Service Campaign Bulletin

Torque Checks and Pipe Protection Sleeve Installation

Document Number	14 A 001
Campaign Reference	04E
Affected Vehicles	720S
Date Released	21 st June 2017
Version	1

Airbrake Panel Instructions

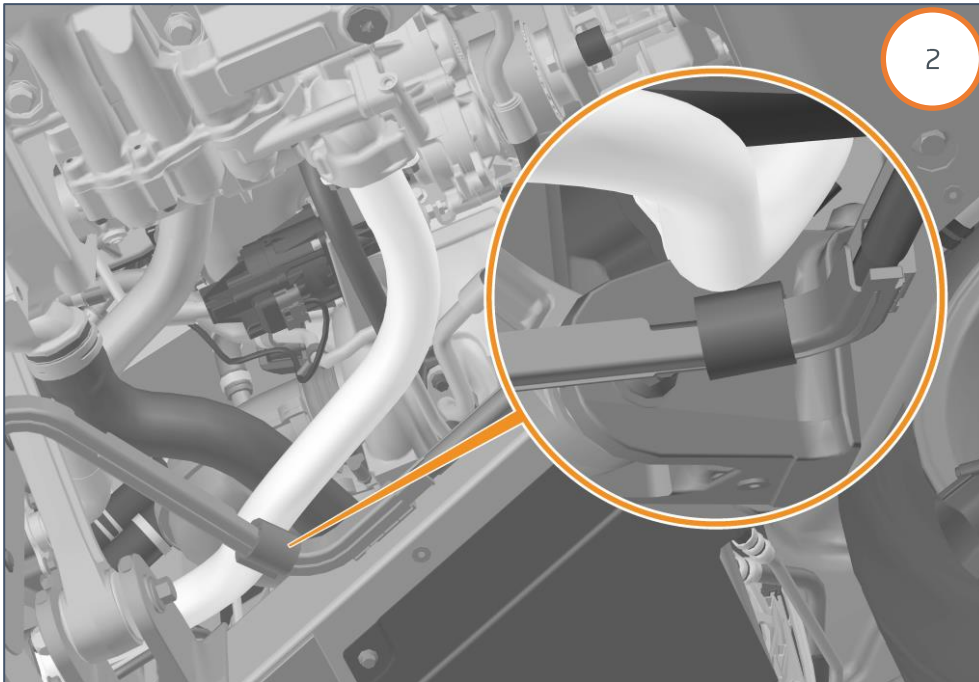
1. Turn the ignition ON.
2. Press the ACTIVE button to switch on the active dynamics panel.
3. Press the AERO button to raise the airbrake panel.
4. Check the torque (14Nm) of the airbrake panel mounting bolts M6 x 18 (1). If one or more are found loose, retorque to the correct value 14Nm.

Rear Damper Instructions

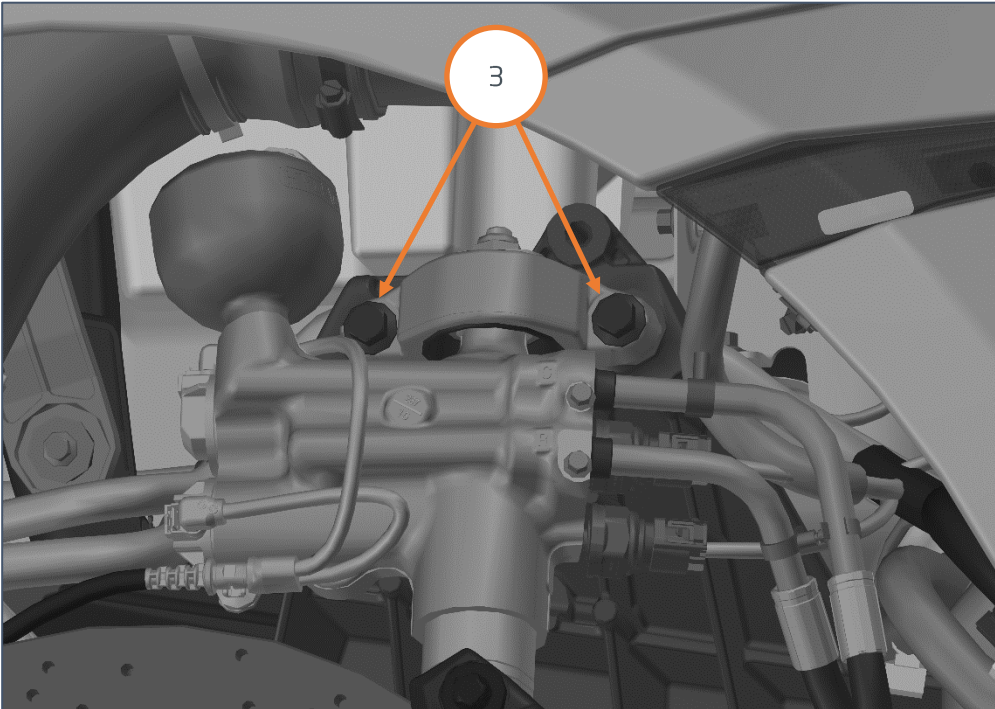
Care Point: Please ensure the torque check is completed on both left and right hand side.

1. Please refer to SIS "DA-RM-04B005-01-001 - Remove/Install wheel - Rear" to remove the rear wheels.
2. Please refer to SIS "DA-RM-03A076-02-001 - Remove/Install wheelarch liner - Rear" to remove the wheelarch liners.
3. Check the torque (57Nm) of the top bolts M10 x 40 (3). If one or more are found loose, retorque to the correct value 57Nm.
